SUNDRY NOTICES AND REPORTS ON WELLS

SJ 32-8 Unit #250A

Configuration Chng

To request an exception to Onshore Order #2 to:

For Drilling to Intermediate Casing Point & Setting 7" Intermediate Casing

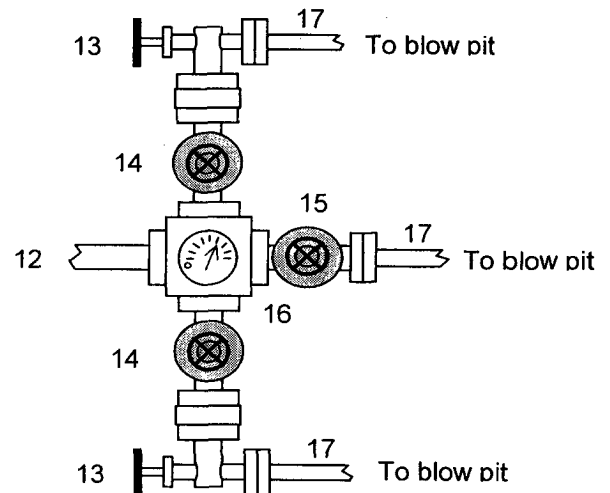
- allow us to test our BOP and 9-5/8" surface casing to 1000 psi in lieu of Onshore Order #2 requirements
- to specify our BOP Program for our cavitation operations and allow us to test our BOP and 7" casing for the cavitation program to 1800 psi in lieu of Onshore Order #2 requirements.

A 12-1/4" hole will be drilled to approximately 220' and the 9-5/8" surface casing will be run and cemented. The Casing Head "A" Section will be screwed onto the 9-5/8" surface casing stub. The BOP will be installed on the Casing Head "A" Section. A test plug will be set in the wellhead and the pipe rams and choke manifold will be tested to 200 psi to 300 psi (low pressure test) for 2-3 minutes and to 1000 psi (high pressure test) for 10 minutes. Then the test plug will be removed, and the **9-5/8" casing will be pressure tested** against closed blind rams to 200 psi to 300 psi for 2-3 minutes and to **1000 psi for 30 minutes** (this value is one 44% of the minimum internal yield pressure of the 9-5/8" casing). (Note: per regulatory requirements we will wait on cement at least 8 hrs after placement before testing the 9-5/8" surface casing). Then an 8-3/4" hole will be drilled to intermediate casing point and 7" intermediate casing will be run and cemented.

For Cavitation Program

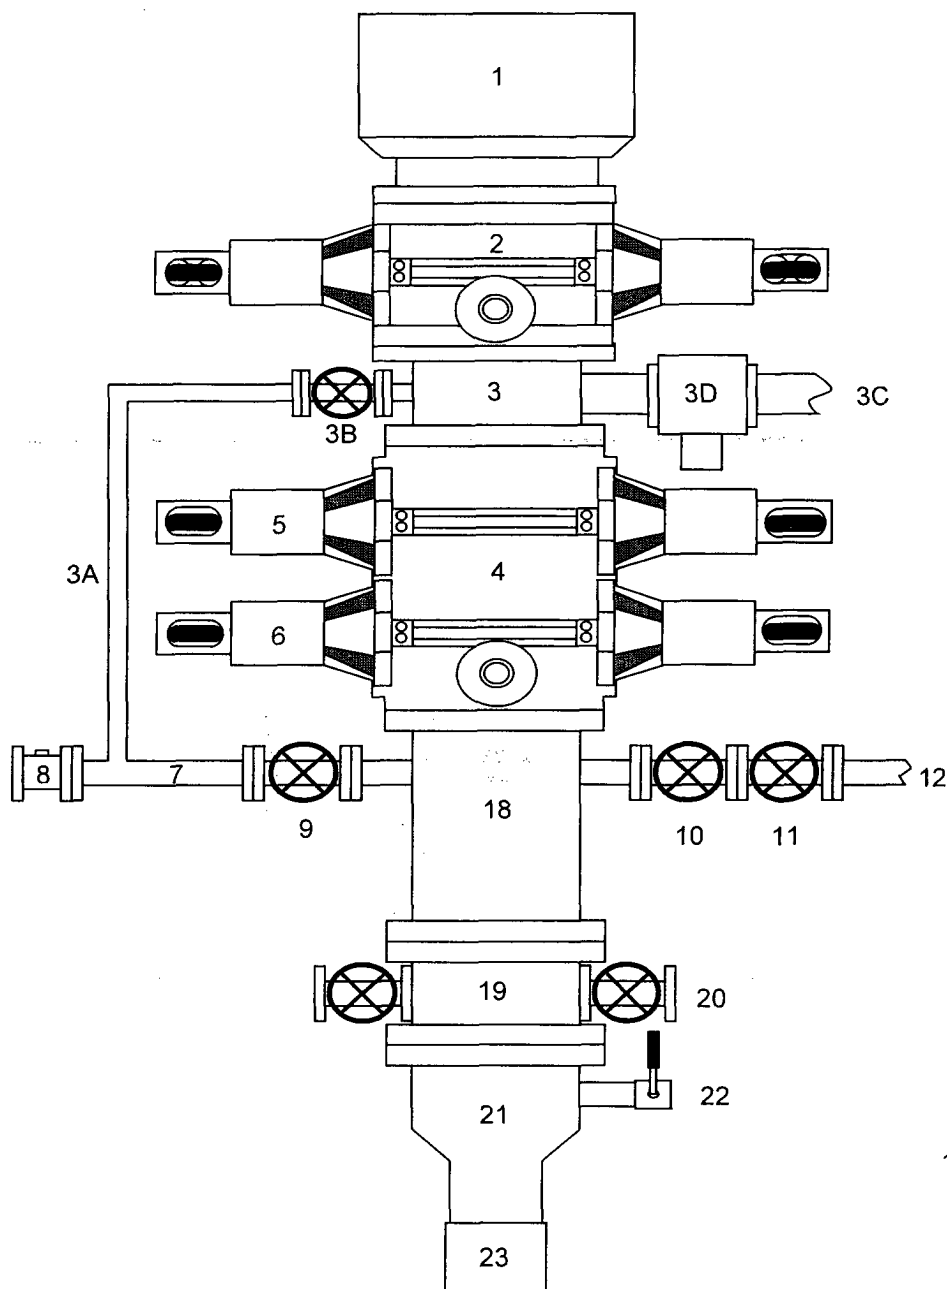
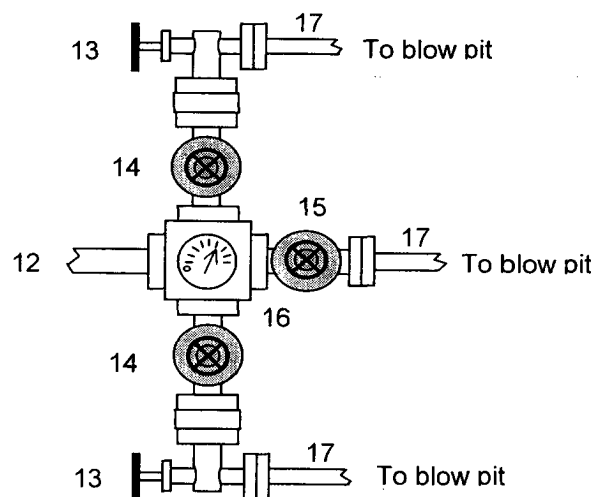
This BOP arrangement and test program is for the cavitation program. The BOP will be installed on the tubing head. The 7" casing will be pressure tested against closed blind rams to 200 psi to 300 psi for 2-3 minutes and to 1800 psi for 30 minutes - this test pressure is 48% of the minimum internal yield strength of 3740 psi for the 7", 20#, J-55, STC casing. The pipe rams and choke manifold will be tested to 200 psi to 300 psi (low pressure test) for 2-3 minutes and to 1800 psi (high pressure test) for 10 minutes - This test will be done with a test plug or possibly without a test plug (ie against casing). If we conduct this test without a test plug we will ensure that we have sufficient drillstring weight in the hole to exceed the upward force generated by the test.
